Access Compliance Report Public Rights-of-Way (Curb Ramps)

Main Street: BARNSTABLE_WAY		Cross Street: RESTON_WAY		Location:	S
ADA ID: RPRK211101125612	Ramp Type: Type 4 - Parallel	Initial Pass/Fail: Fail	Overall Compliance: No	Severity Score:	20

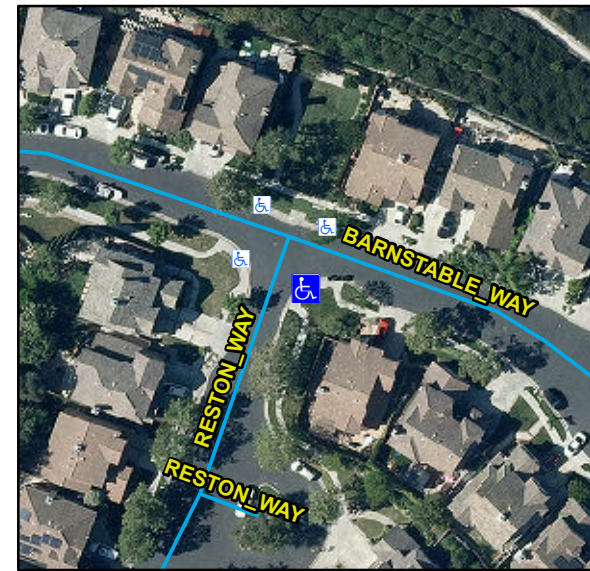
Compliance	Description	Data	Compliance	Description	Data
N/A	Ramp Length LT (in)	108	N/A	Ramp Length RT (in)	111
No	Ramp Width LT (in)	47	No	Ramp Width RT (in)	47
No	Ramp Run Slope LT (%)	10.5	Yes	Ramp Run Slope RT (%)	2.1
No	Ramp Cross Slope LT (%)	2.8	Yes	Ramp Cross Slope RT (%)	1.3
N/A	Landing Present	N/A	N/A	DWS Provided	N/A
N/A	Landing Length (in)	N/A	N/A	DWS Contrast	N/A
N/A	Landing Width (in)	N/A	N/A	DWS Length (in)	N/A
N/A	Landing Run Slope (%)	N/A	N/A	DWS Full Width	N/A
N/A	Landing Cross Slope (%)	N/A		DWS Offset Type	N/A
N/A	Landing Movement Obstructed?	N/A	N/A	DWS Offset Left (in)	N/A
	Landing Movement Type	N/A	N/A	DWS Offset Right (in)	N/A
N/A	Landing Shared	N/A			
N/A	Clear Space	Yes			
N/A	Clear Space To Crosswalk (in)	N/A			
N/A	Marked Crosswalk 1	No	N/A	Marked Crosswalk 2	No
	Crossing 1 Direction	NE		Crossing 2 Direction	NW
	Marked Crosswalk 1 Width (in)	N/A		Marked Crosswalk 2 Width (in)	N/A

N/A	Ramp Inside Crosswalk 1	N/A	N/A	Ramp Inside Crosswalk 2	N/A
	Crossing 1 Slope (%)	0.8		Crossing 2 Slope (%)	0.6
	Crossing 1 Cross Slope (%)	2.5		Crossing 2 Cross Slope (%)	3.4
N/A	Gutter Ponding	N/A	N/A	Curb Slope	8.4
Yes	Gutter Lip Height (in)	0		Road Run Slope (%)	4.1
N/A	Gutter Run Slope (%)	N/A		Road Cross Slope (%)	3.7
N/A	Gutter Cross Slope (%)	N/A	No	Perpendicular Joint Present	No
Yes	Overall Surface Condition	Acceptable			
	Cross Gutter Present?	No		Spandrel Present?	No
	Replace Cross Gutter?	N/A		Replace Spandrel?	N/A

Remove & Replace Curb Ramp With Two New Directional Ramps or Equivalent.
